ERIE AIR PARK REPLAT D

Reference: PUD and Minor Subdivision Comment Response Letter
PUD-001122-2019 and MS-001121-2019
Lot 1 – Erie Air Park Replat D
2800 Airport Drive – Erie, Colorado

The following is a line item response to the Town of Erie review comments dated January 29, 2020 for the above referenced project. The comments are listed below with responses in italics. Please let us know if you have any questions or need any further clarification regarding these issues.

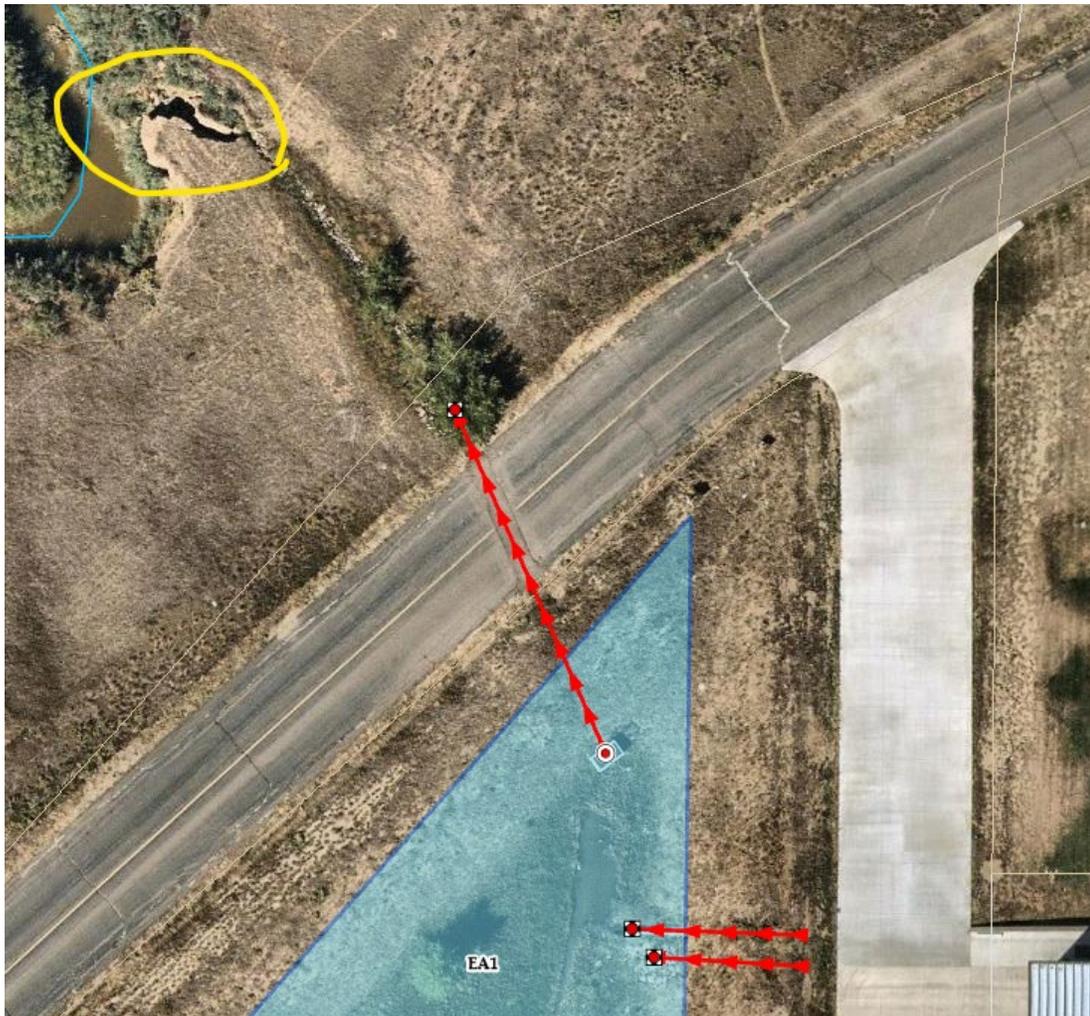
The mouth of the drainage swale/ravine that is to be used for outflows from the detention pond into Coal Creek is experiencing significant erosion – see aerial photos below. Review the current situation and provide the necessary stabilization measures to address the problem and prevent future erosion.

As you are aware, this section of Coal Creek was heavily damaged during the flooding event of 2013. The steep banks left after the flood have yet to be repaired, which has obviously been undermined and somewhat affected by our site drainage. We would be willing to discuss repair options as part of the broader repair project, or something more isolated in order to stabilize the offsite drainage. Any repair must be sensitive to permitting constraints.
